CCR-81

REQUEST FOR INFORMATION NOT ADDRESSED IN THIS CCO REMAIN IN FORCE

SAS SUPERSTRUCTURE ROADWAY WESTBOUND
LIGHTING AND ELECTRICAL SYSTEMS

SKETCH No. CCR-81-SK-E-46 R1

E-160A

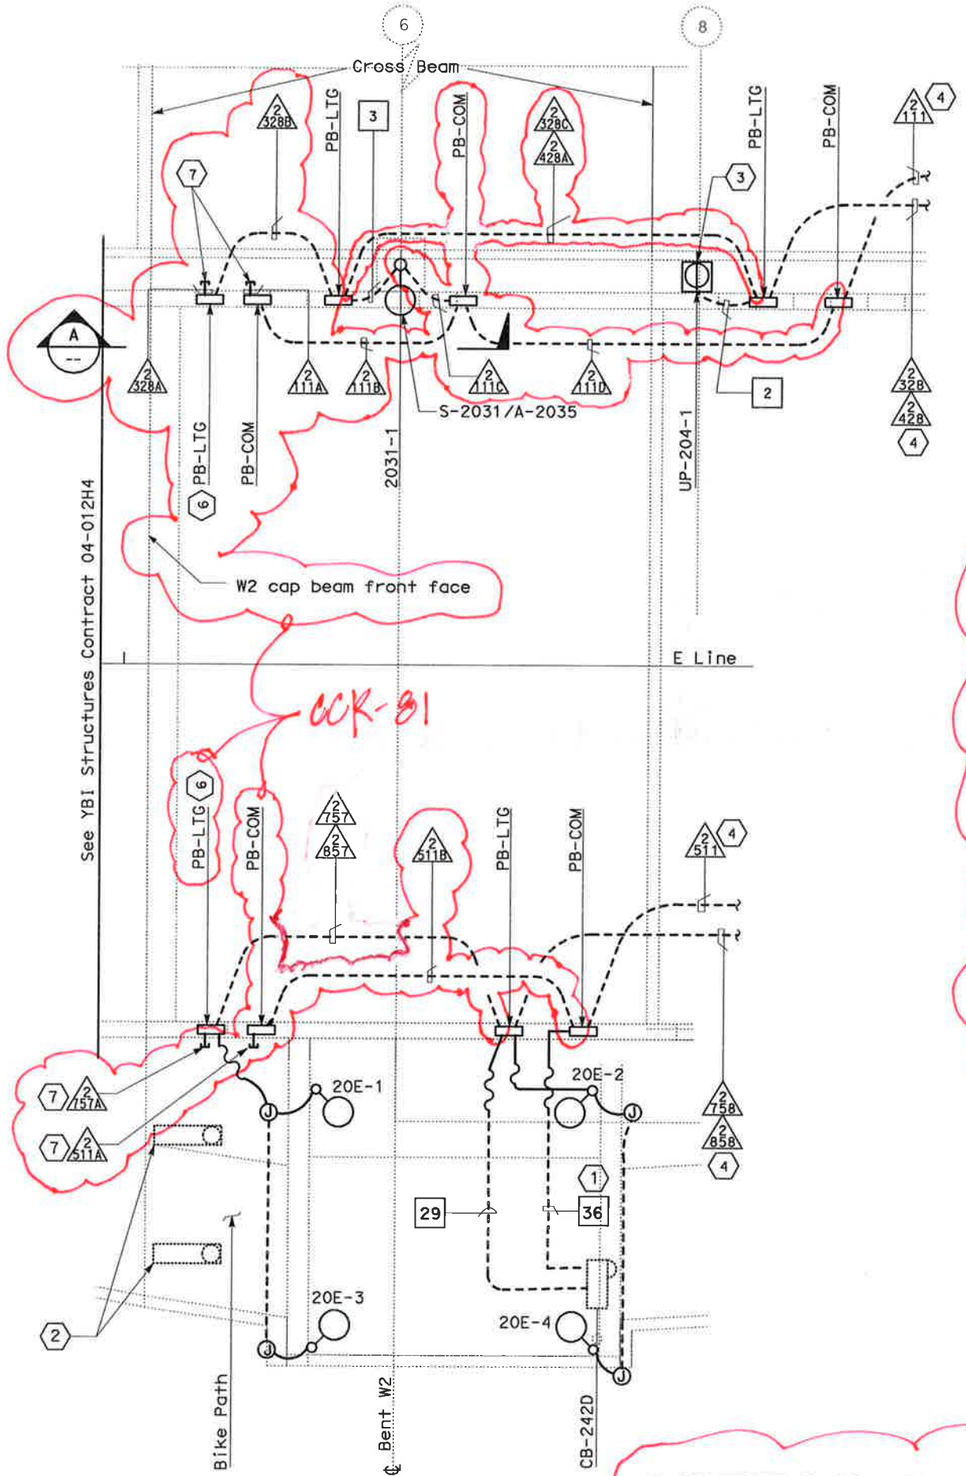
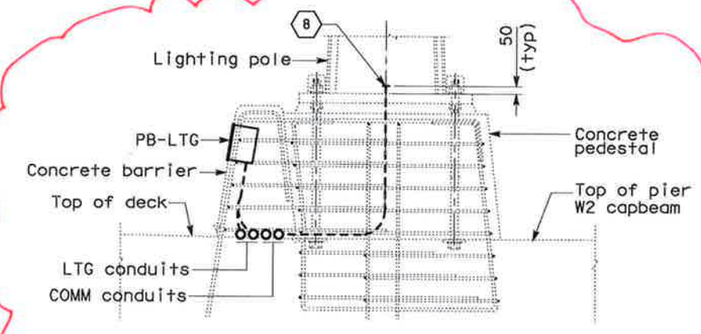
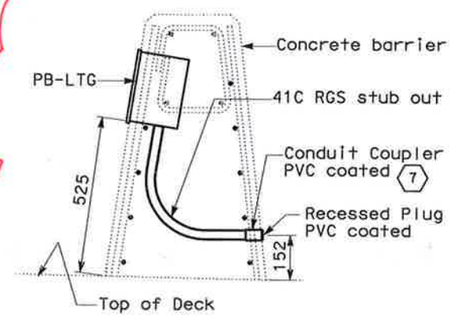
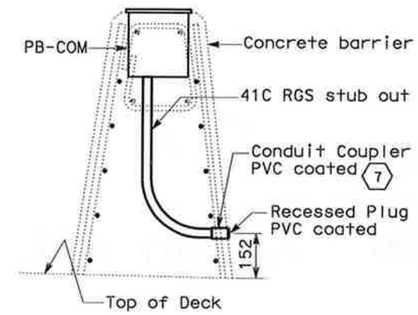
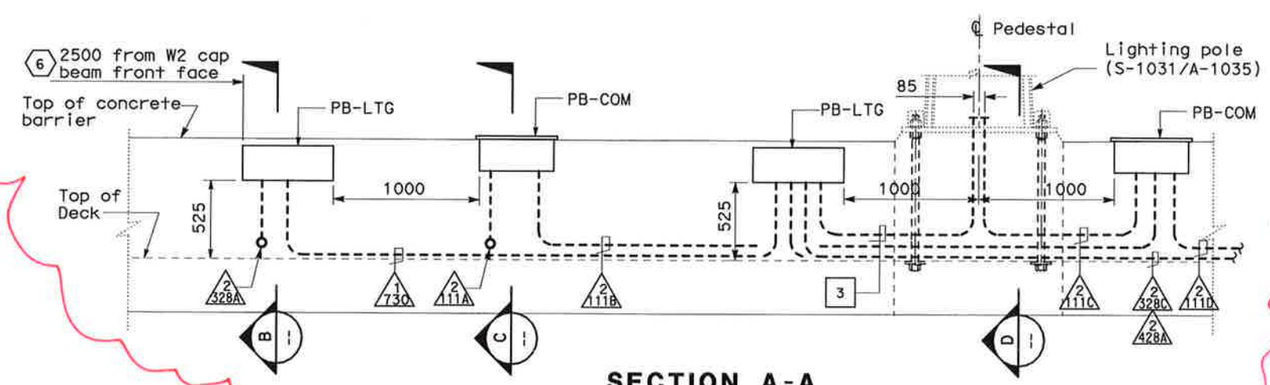
1. Contractor shall coil 30 meters inside cable tray for feed into PB-COM by others.
2. Railing lights are conrtractor furnished and installed by others.
3. Roadway Barrier Receptacle, see Detail 1, sheet E-68.
4. See drawing E-135 for continuation of conduits.
6. Contractor shall verify dimension and locate PB-LTG with sufficient distance to accommodate required clearance for the expansion joint.
7. Conduit shall be stub-out at the non-roadway side of the barrier with the coupler flushed to the barrier face wall.
8. Capped end of conduit stub-ups.

1. Bike path electrical components west of PP-9 are furnished by contractor and installed by others.
2. For additional general notes, see E135.
